From: [Jonathon Thompson](#)
To: [Philip Nevill](#)
Cc: [Ellie Evans](#); [Rob Morris](#); [Gabrielle Allan](#); [Gen Lucas](#)
Subject: RE: New Cobar Complex Project SSD-10419 - Request for Additional Information
Date: Thursday, 18 November 2021 1:23:00 PM
Attachments: [~WRD0977.jpg](#)
[image001.jpg](#)
[image004.jpg](#)
[image005.jpg](#)
[image006.png](#)
[New Cobar Complex Project - Advice re Unused Rail Corridor\(517112074.1\).pdf](#)
[J190278_Cobar_RTS_GWmemo_addendum_v1.pdf](#)
[J190278 New Cobar Complex - response to NSW Health_v1.pdf](#)

New Cobar Complex Project (SSD 10419) Advice in relation to Unused Rail Corridor Land

To: Jonathon Thompson, Peak Gold Mines
From: Joel Georgiou and Tom Neill
Subject: New Cobar Complex addendum to the Groundwater Impact Assessment

Re: New Cobar Complex Project - Response to Submissions Air Quality Impact Assessment Update

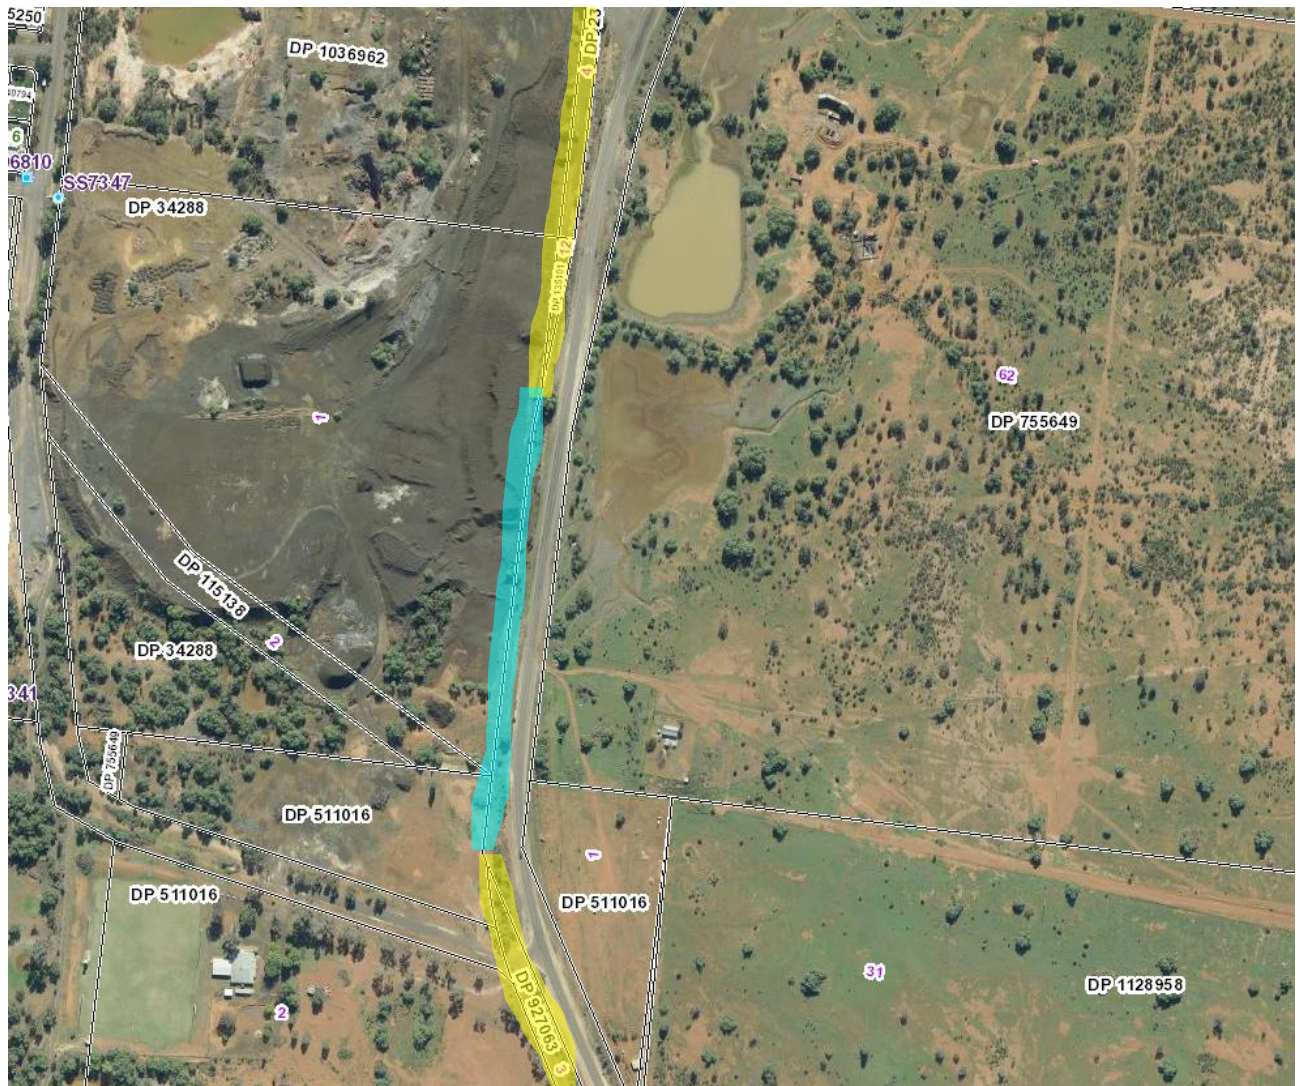
- 1.6 We have searched the land identified as the rail corridor by John Holland and have identified portions of Rail Corridor Land along the western boundary of the Kidman Way (to the north and south of Lot 1 in DP 34288), which are freehold land in Auto Consol 1617-78, comprising the parcels of land in folio identifiers 12/135101, 4/234069, 7/234069, 1/927063, 3-4/927063.
- 1.7 Those parcels of land in the relevant area are shown highlighted yellow in the map below:

- 1.8 We have not identified, after several hours of searches, any separate parcels of land reserved for rail purposes in the area between the southern portion of Lot 1 in DP 34288 and the Kidman Way (area highlighted in blue on the above map). This does not mean that there is no Rail Corridor Land in that location. However, the information provided by John Holland and the details contained in Government Gazette 821 of 1.10.1901 Folio 7568 and Government Gazette 995 of 26.11.1209 Folio 9123, which John Holland has indicated created the Rail Corridor Land, are insufficient to confirm whether the Rail Corridor Land includes the blue portion of land above.
- 1.9 We understand that Peak has requested further evidence from John Holland that the Rail Corridor Land includes the land highlighted blue above.

- 3.7 While we have assumed for the purpose of this advice that there is Rail Corridor Land in the location marked blue on the figure in paragraph 1.7, being the location where we understand the Great Cobar Pipeline crosses between the Kidman Way and Lot 1 in DP 34288, it must also be noted that the existence of Rail Corridor Land in that location has not been established by JHR or TfNSW. As outlined above, our investigations were not able to confirm the existence of Rail Corridor Land in that location. A condition of consent requiring Peak to enter into a licence with JHR or TfNSW in respect of land that, at best, is owned by TAHE and at worst, is not in fact Rail Corridor Land is likely in our view to also be invalid for unreasonableness.

Figure 3.2 Modelled groundwater elevation hydrographs at water supply work GW309105

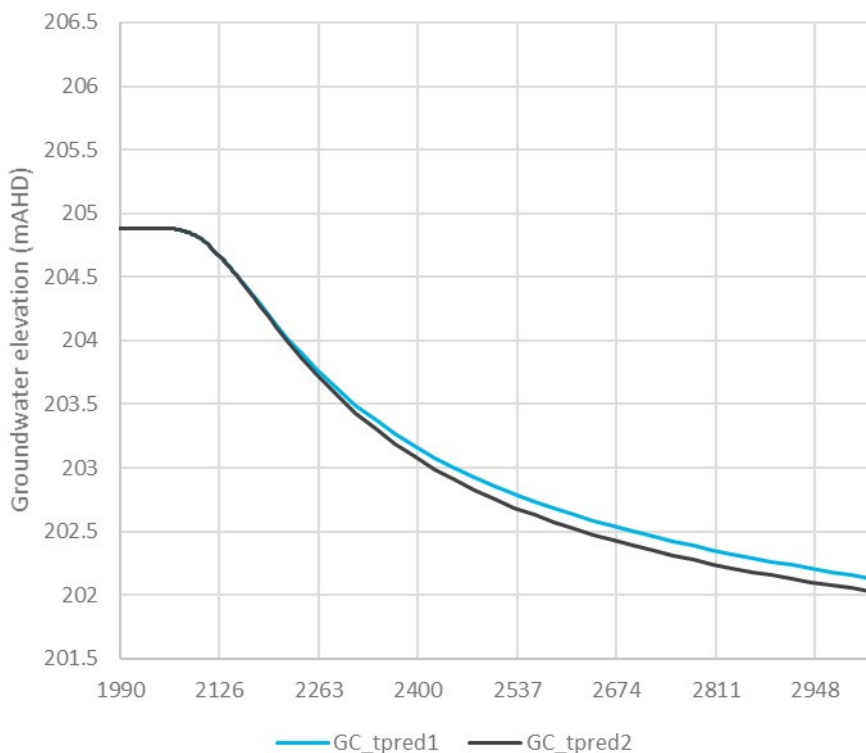
Following submission of the RTS, the groundwater bore analysed by EMM (2021c) was determined to have been derived from an incorrect location. The bore (85WA752553, also known as GW309105) is located approximately 9 km to the southwest of Cobar, as shown in Figure 3.1. The bore lies outside of the modelled induced 2.0 m drawdown contour for all four prediction scenarios, caused by the combined water take (pit dewatering and all water supply activities) concerned with the New Cobar Complex project. This was originally presented by EMM (2021b), and as such the planned mining is not expected to induce a significant impact on this bore.

Figure 3.2 shows modelled hydrographs at GW309105 for the base case predictive model scenarios, showing modelled induced drawdown and recovery following mine dewatering.

The scenarios show modelled absolute drawdown at GW309105 of greater than 2 m relative to pre-1990 levels, increasing at the end of the 1,000-year post-mining period. This is likely associated with ongoing groundwater discharge at the New Cobar open cut pit (caused by evapotranspiration), in addition to the impacts already caused by the historical Peak operations. Impacts associated with historical mine activities are not assessable in this case.

The maximum predicted drawdown at water supply work GW309105 caused by the project activities is less than 2 m, with the majority of drawdown being attributed to pre-existing mining activities rather than planned activities as per the GIA (EMM 2021b). Given the predicted drawdown is not expected to exceed Level 1 minimal impact considerations, it is unlikely that PGM will need to consider make-good measures under the AIP.

Figure 3.3 Modelled mine void uncertainty analysis groundwater elevation hydrographs at water supply work GW309105

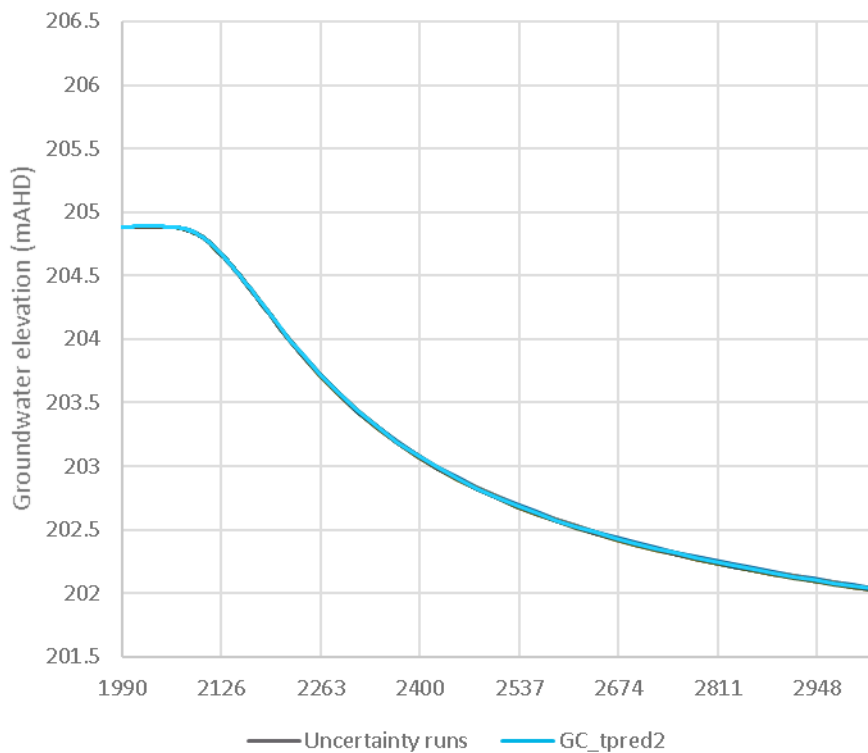
Modelled groundwater hydrographs at GW309105 for GC_tpred2 and the void properties uncertainty runs are presented in Figure 3.3. As with the maximum spatial extent of drawdown, the void geometry and adopted parameters have very little influence on regional drawdown effects, including at GW309105.

Figure 4.1 Modelled watertable elevation at open cut pits

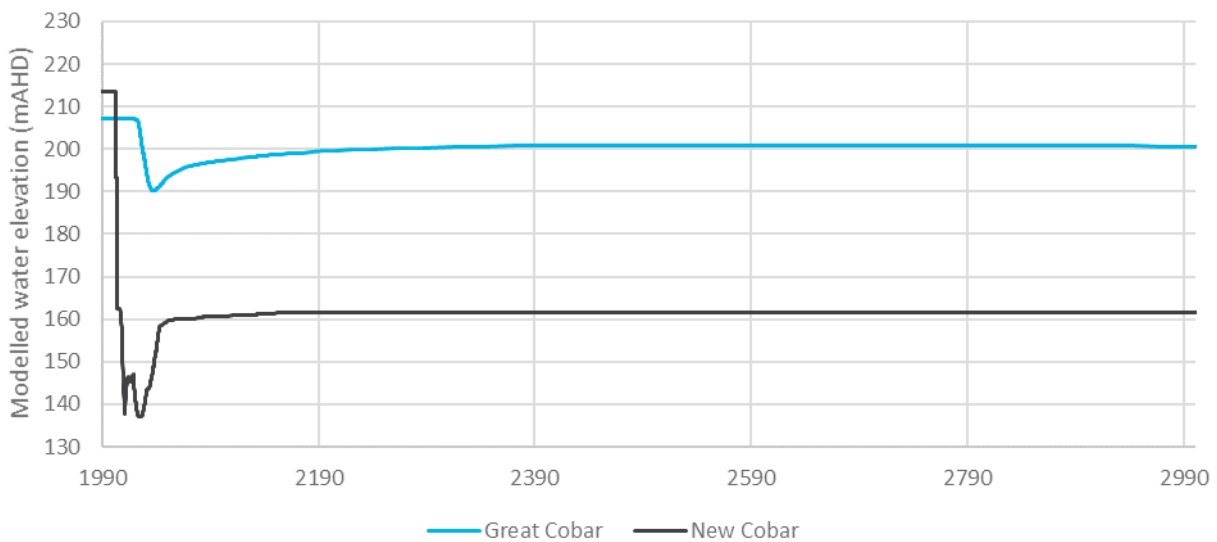
Additional commentary in response to the independent peer review of the model (EMM 2021c) was requested by DPIE, particularly Sections 3.5 to 3.9 regarding post-closure groundwater conditions at the two open cut pits (Great and New Cobar). For reference, the way the open cut pit features are modelled is summarised in Table 4.1. The Great Cobar pit is a historical feature and is a known pit lake, whereas the New Cobar pit was developed during the history-matching period of the simulation and remains dry as of 2021. As such, simulation methods were different for each pit.

Modelled hydrographs at the Great Cobar and New Cobar pits are presented in Figure 4.1. Changes in water level at New Cobar are caused by active dewatering during mining, and changes at Great Cobar occur in response to nearby mine activities. Following cessation of mining, partial recovery of watertable elevation is simulated to occur at both pits. The watertable level recovers to the base of the New Cobar pit within approximately 100 years. Water in the Great Cobar pit recovers more gradually, stabilising approximately 6.5 m below pre-1990 levels. Long-term, it is conceptualised that the New Cobar pit will remain dry or form a pit lake below regional groundwater levels, causing a permanent groundwater depression.

Figure 4.2 Modelled post-mining groundwater discharge to New Cobar open cut pit

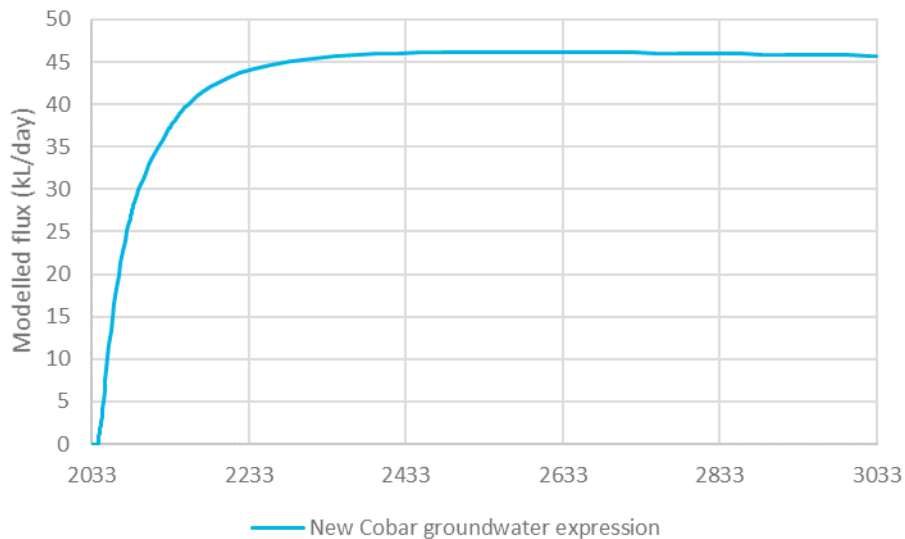
Modelled groundwater inflows to the New Cobar pit following mining are presented in Figure 4.2. Inflows increase over time as the groundwater level recovers around the pit, stabilising at approximately 45 kL/day. Other water fluxes to/from the pit include incident rainfall (300 mm/year) and pan evaporation (2,400 mm/year).

Figure 4.3 Simulated development of pit lake salinity

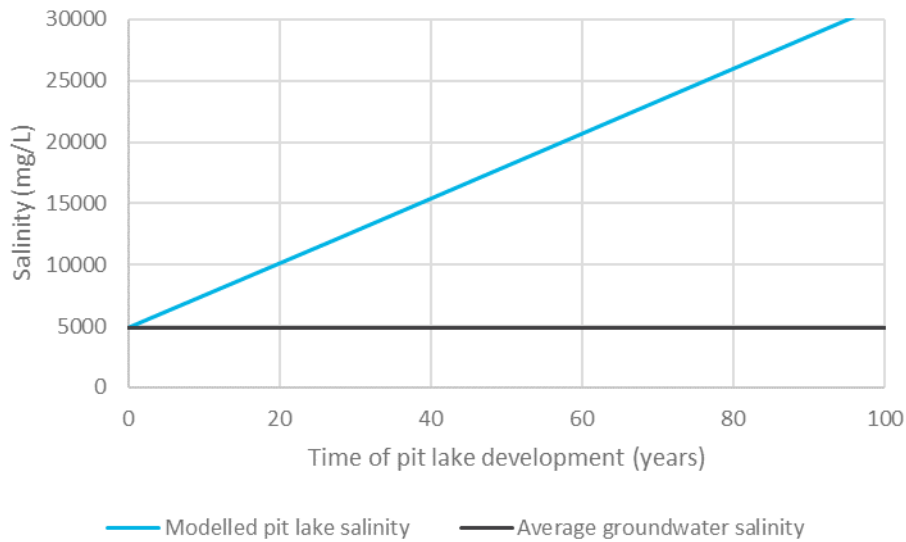
Measured groundwater salinity in the area has an average TDS of 4,825.6 mg/L (EMM 2021b). Assuming maximum groundwater inflow of 45 kL/day, this equates to a dissolved salt mass of 217.2 g/day entering the pit lake. Consistent groundwater inflow at this rate would result in a pit lake surface at 208 mAHD, with maximum water depth of 50 m and total standing water volume of 299,576 kL. Assuming that rainfall and evaporation contribute no salt flux, the simulated temporal progression of pit lake salinity is presented in Figure 4.3. With a starting salinity of 4,825.6 mg/L (assuming all initial incident rainfall is removed by evaporation), this suggests approximately 20 years of groundwater inflow would need to occur before the pit lake salinity doubles average groundwater values. It should be noted that this constitutes a conservative upper bound assessment based on the assumption that groundwater inflows do not reduce over this time.

Figure 2.1 Percentage lead in Hera HVAS samples – Feb 2020 to Sep 2021

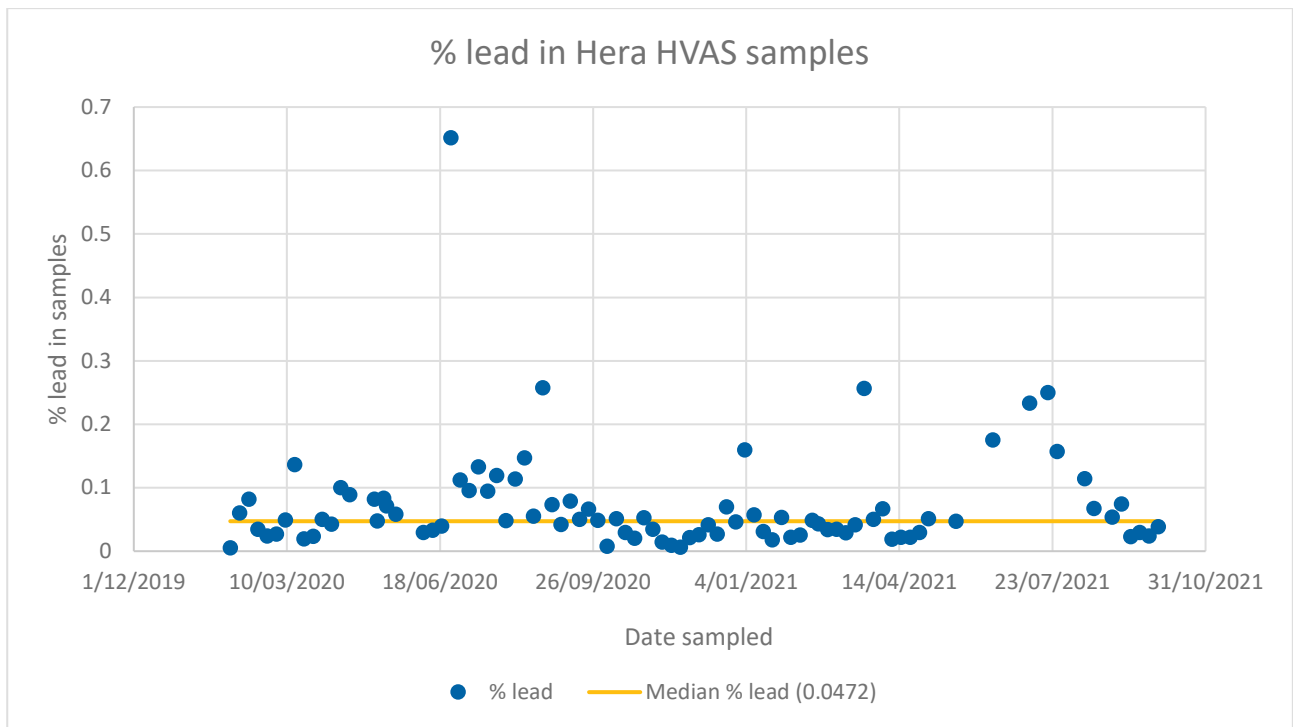
2.3 Comment 2

In response to the comment from NSW Health, PGM has provided additional data from February 2020 to September 2021 from both Cobar and Hera HVAS to confirm the assumptions that underpinned the AQIA and HHRA.

The data from the Hera HVAS is presented below in Figure 2.1, and demonstrates that the median lead concentrations in PM₁₀ generated from operations at Hera during this time period is in the order of 0.04-0.05%. While this is a minor increase in the concentration used in the AQIA, the lead concentrations in ambient air remain very low and do not change the conclusions of the AQIA.

Figure 3.1 New Cobar Complex material movement annual variation

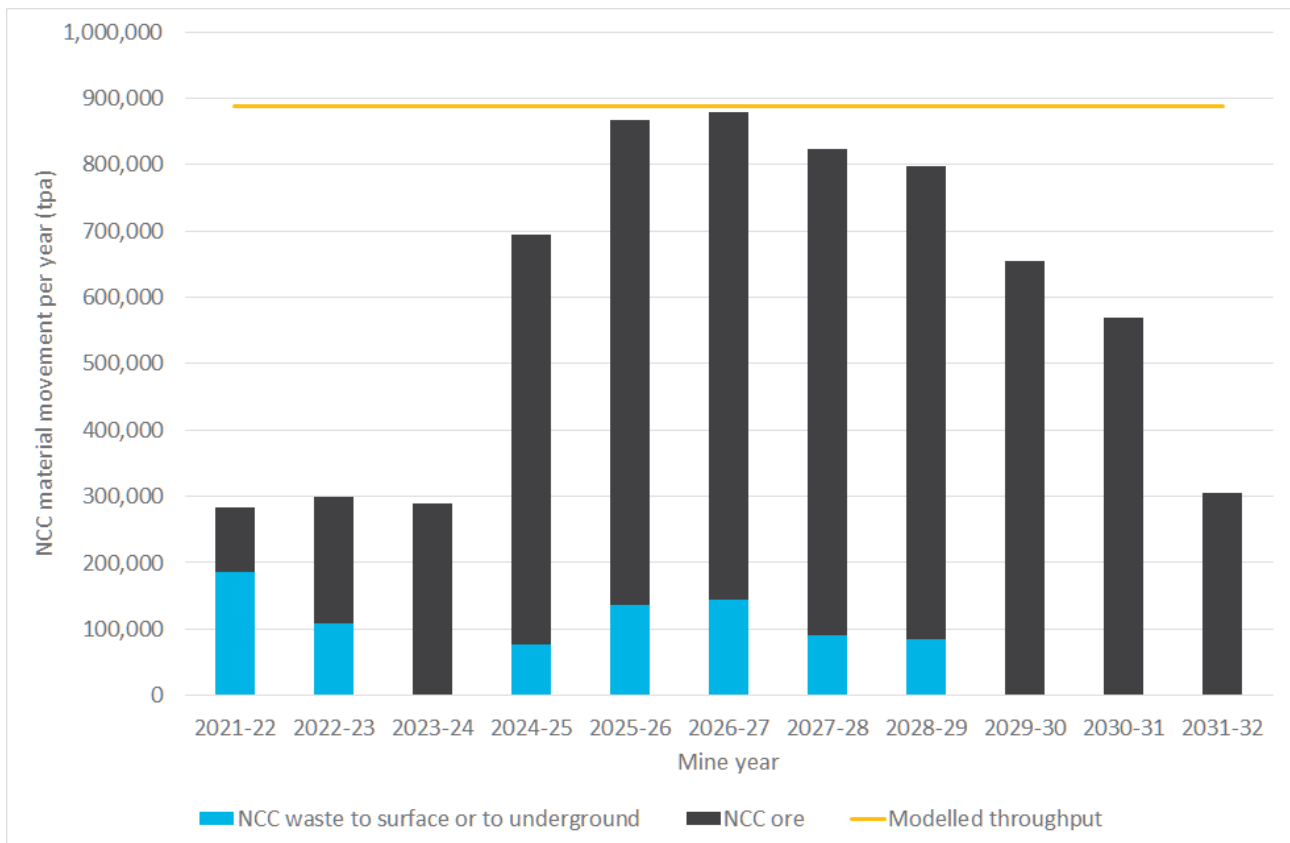
3.1 EPA comment

Since submission of the EIS, a more detailed year by year breakdown of material movements at New Cobar was prepared after the completion of the AQIA modelling. The projected breakdown of material movement by mine year, along with the AQIA assumed material movement rate of 880,850 tpa, is shown in Figure 3.1.

The future projections showed two things:

- the total amount of material (ore, waste from underground, waste to underground) assumed for New Cobar in the AQIA would not be exceeded in any year of the projection presented in Figure 3.1. the amount of waste rock exiting the New Cobar underground and/or returning from the surface waste rock emplacement to underground was overestimated in the AQIA;
- the ore exiting the New Cobar underground would be higher than assumed in the AQIA for several future years; and
- the proportion of ore and waste material exiting the New Cobar underground would vary notably year on year relative to the split adopted in the AQIA;

The financial year 2026-2027 shows the largest amount of material movement from the refined mining schedule. To understand the implications for air quality emissions from the refined material movement profile presented in Figure 3.1, the AQIA emissions inventory for New Cobar complex was revised to the material movement numbers for FY26-27 in the following ways:

Figure 5.1 Contribution to annual emissions by emissions source type and particle size – New Cobar project emission sources

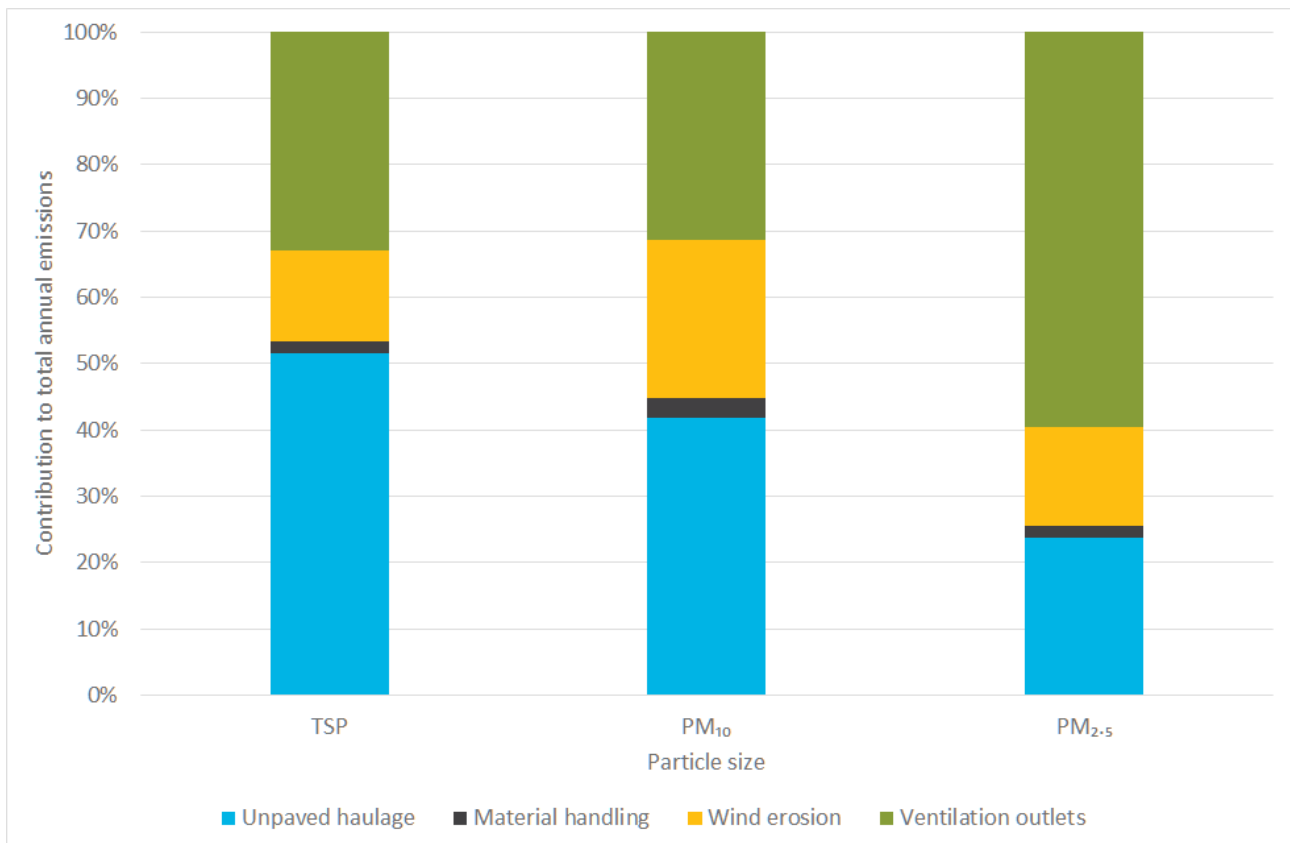
5.1 EPA comment

Section 7.3 of the AQIA details the emissions inventory for the project and emission sources associated with the Peak Complex. The contribution to project (ie related to the New Cobar Complex) particulate matter emissions by source category and particle size fraction is presented in Figure 5.1. The rank of contribution by source type to total annual emissions is presented in Table 5.1.

It can be seen from Figure 5.1 and Table 5.1 that the emissions from unpaved haulage and the proposed new ventilation outlet are the most significant contributors to total project emissions across all particle size fractions. It is highlighted that the emission calculations for ventilation outlet emissions are considered highly conservative due to the application of the maximum recorded in-stack particulate matter concentration from existing ventilation outlets at the site.

Emissions from wind erosion are also reasonably significant contributors to all size fractions. Material handling emissions are relatively minor contributors to annual project emissions.
